Item 1 – JSSD Stillwater Sewer Lift Station Relocation Conditional Use Permit

Project: DEV-11805 | JSSD Stillwater Sewer Lift Station Relocation
Meeting Date: 24 February 2026
Report Date: 16 February 2026
Report Author: Doug Smith, Planning Director
Council Action Required: Yes
Type of Action: Legislative

**Wasatch County
DESIGN REVIEW
COMMITTEE (DRC)
COMMENTS**

PROJECT ID: DEV-11805
PROJECT NAME: CUP - JSSD STILLWATER SEWER LIFT
STATION RELOCATION
VESTING DATE: 11/21/2025
REVIEW CYCLE #: 2

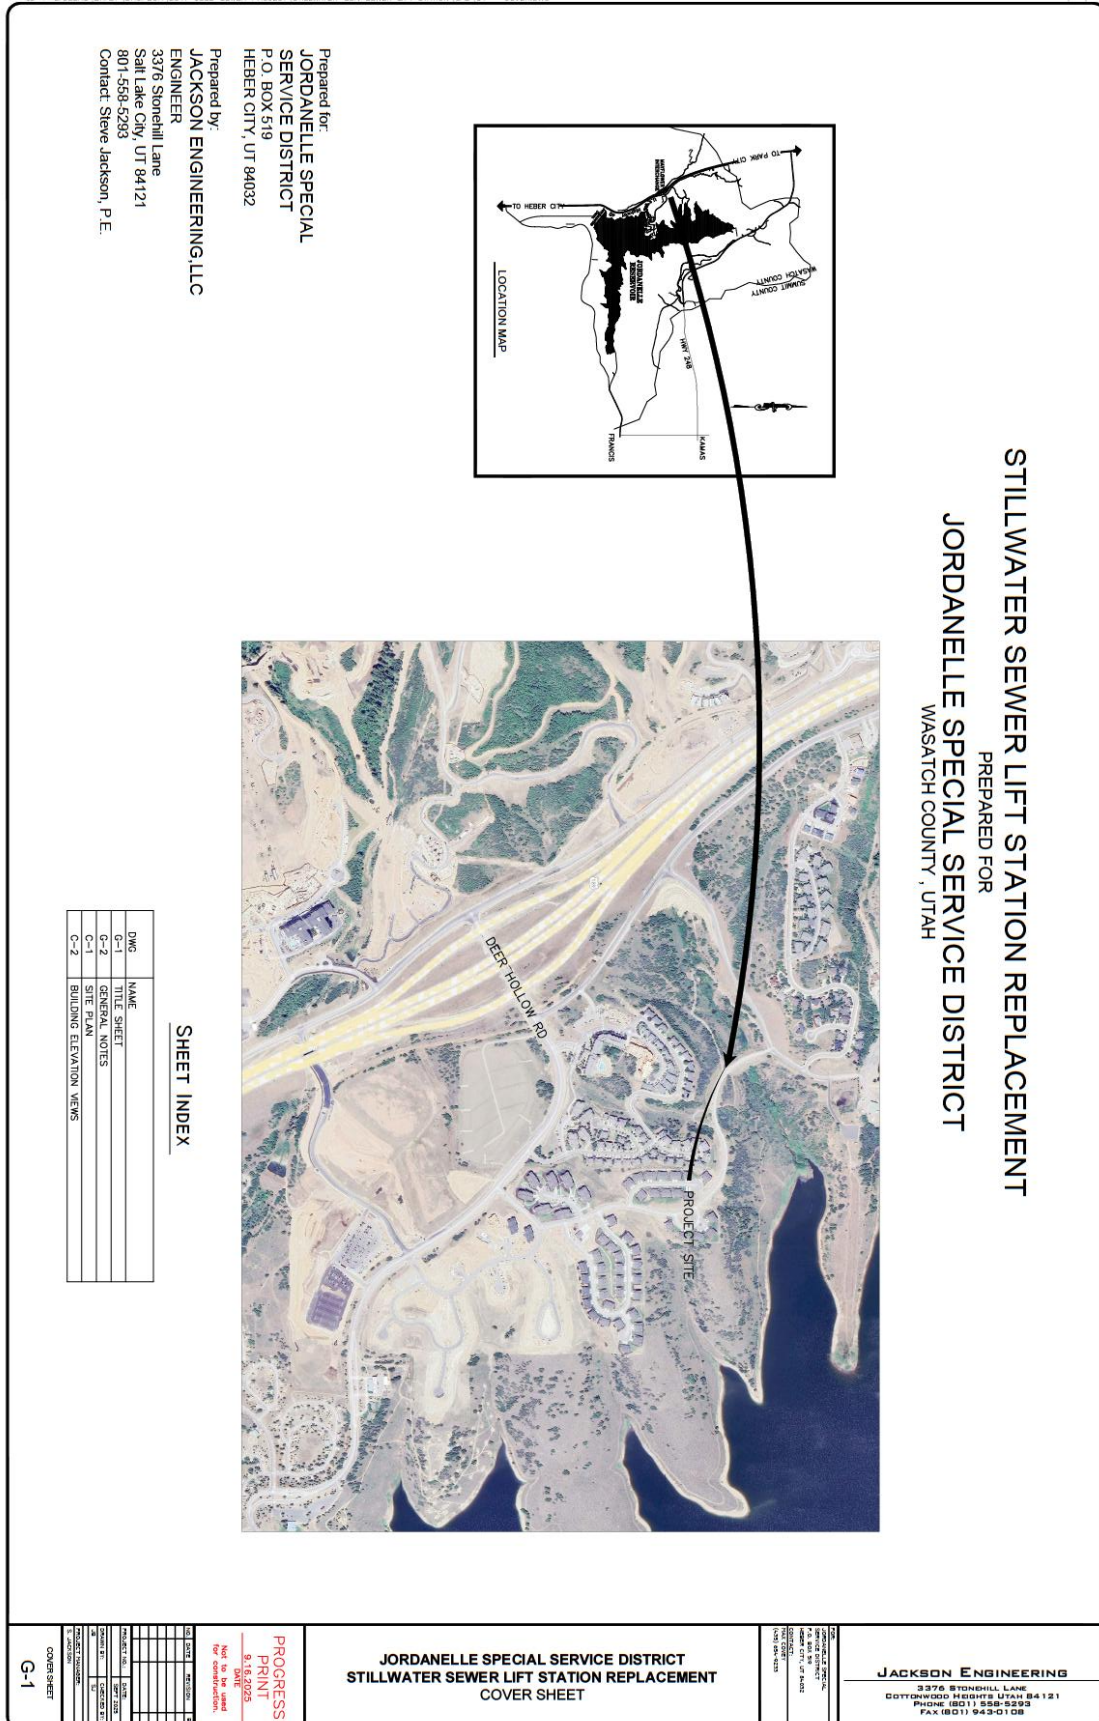
Comment ID	Sheet Name	Comment
DRC-ENG1	03-JSSD Stillwater Replacement Lift Station_Site Plan	2:1 Fill slope will require permanent erosion control blanket or covered with a flexible growth medium.

SOUTHEAST ELEVATION
NOT TO SCALE

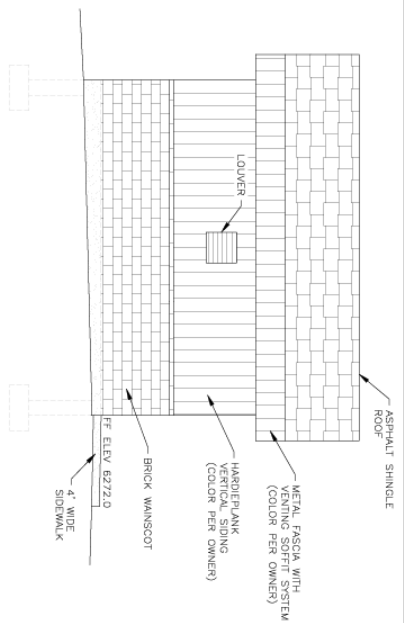
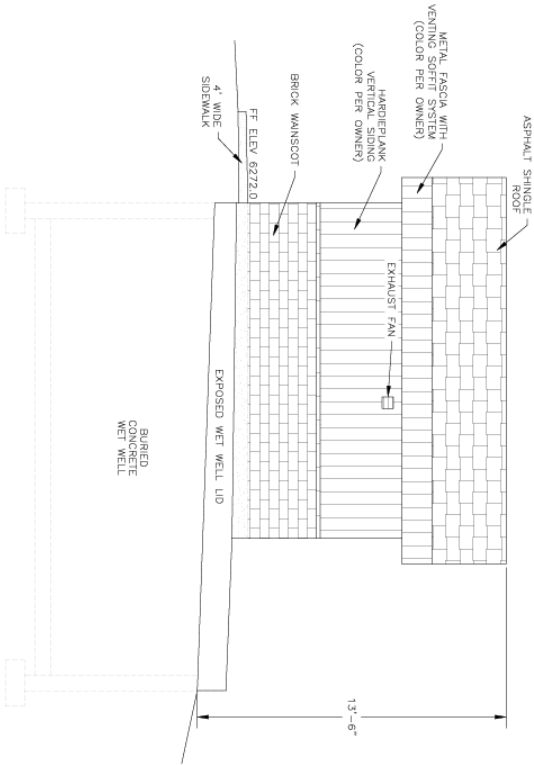
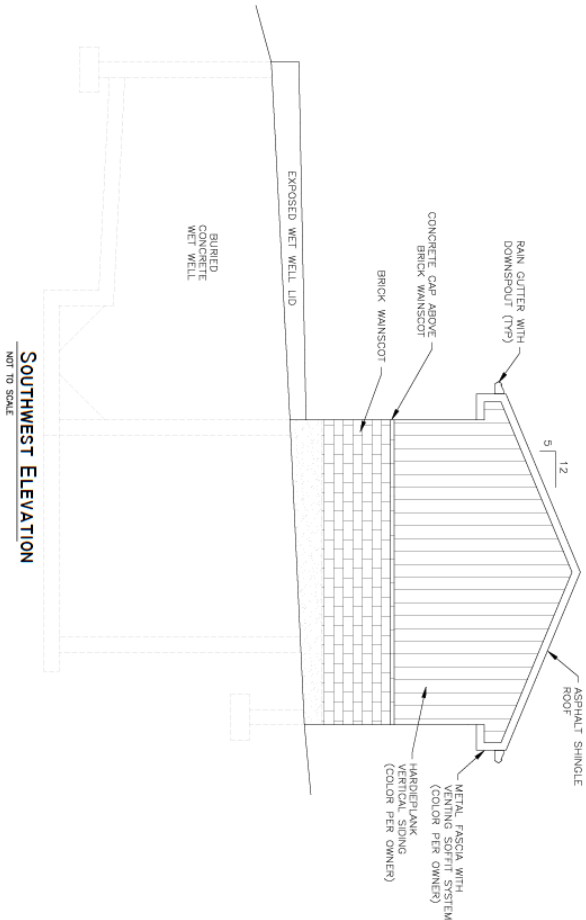
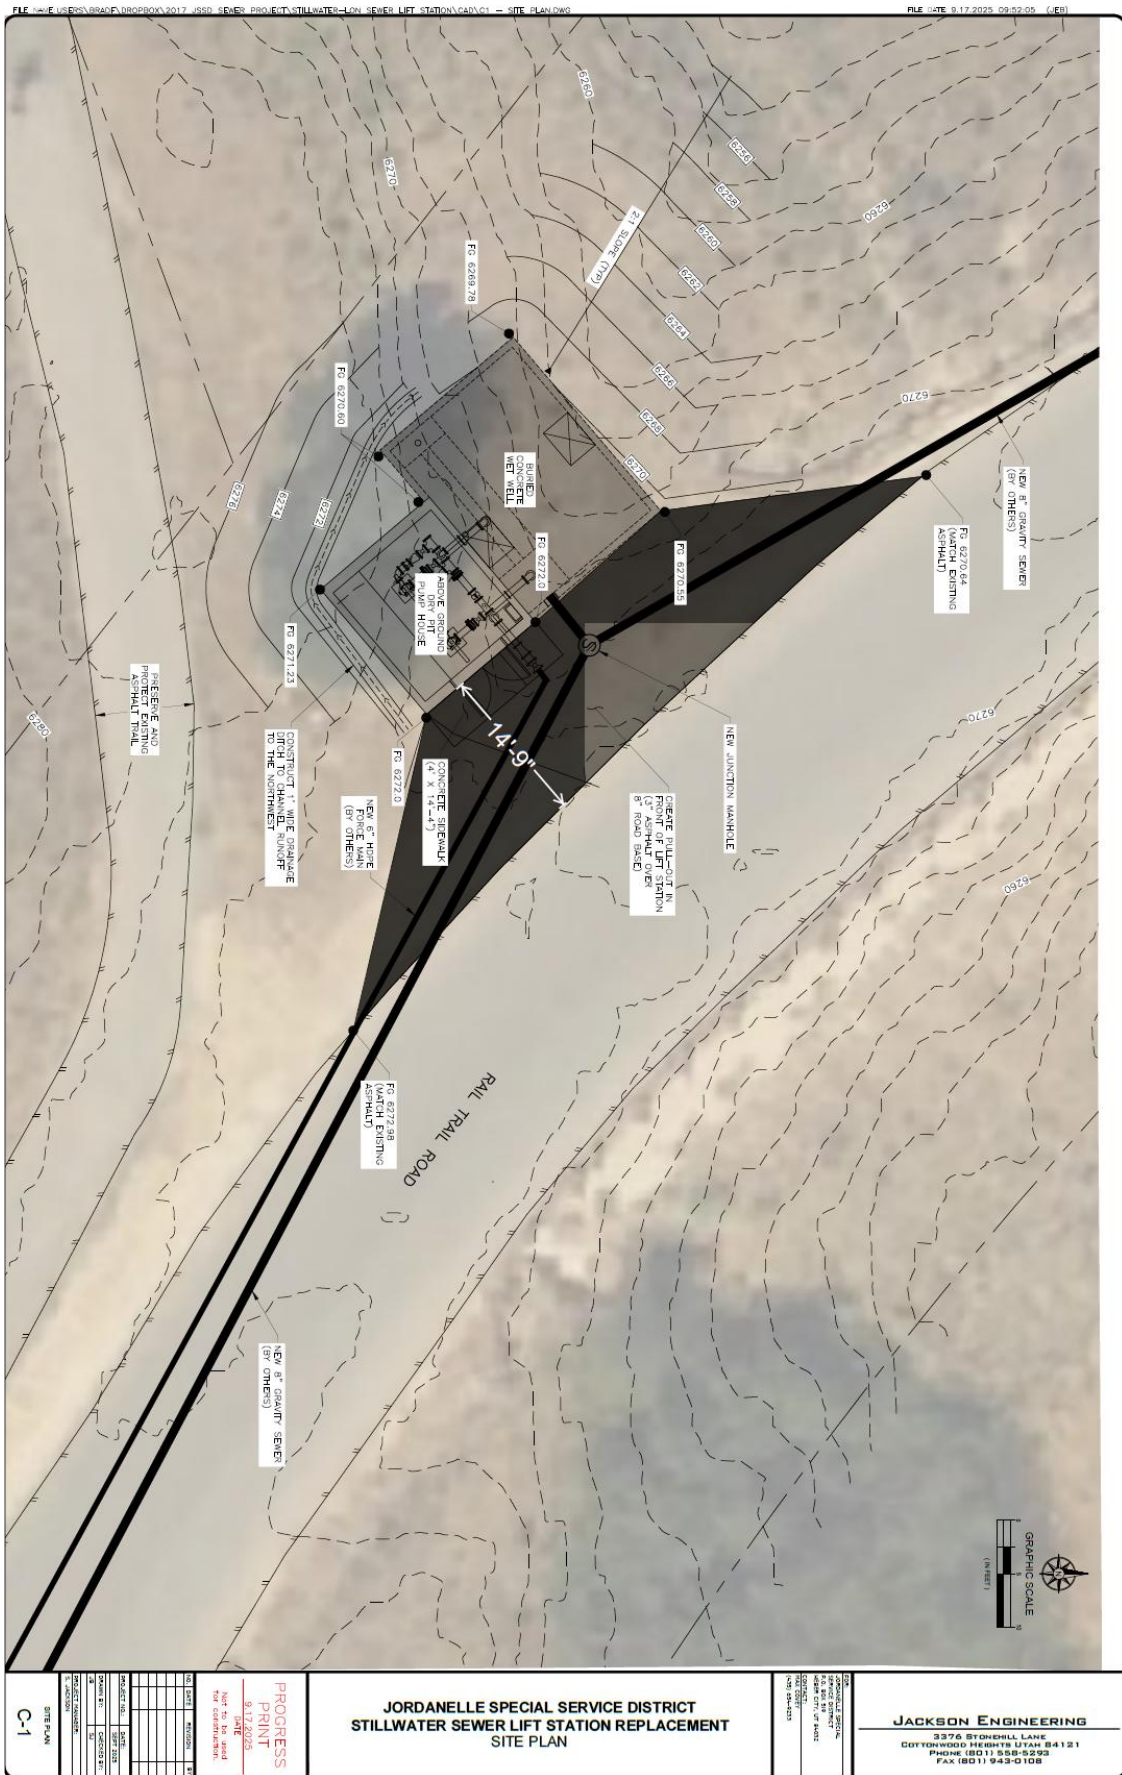
Staff Response: What is visible for the most part will be a 13x15' shed with hardi-plank siding and a natural rock wainscot. There will also be an at grade concrete vault. The building will obviously be smaller in scale than the residential dwellings around it.

1. A minimum of 30% of the total adjusted exterior surface area shall be natural stone or natural stone veneer, and the remaining exterior surface area shall be wood, COR-TEN or blackened steel, fiber board, Cemi-plank or cementitious siding with the appearance of stained natural wood.
2. Superior grade asphalt shingles or standing seam metal roof.
3. Applicant must follow the color palette in the handbook.

1. At building permit the plans must reflect the JSPA design requirements.
2. Lighting if any is required to be full cut off and directed downward.
3. Fencing around the site should not be allowed . The JSPA code discourages fencing (section 7.6)
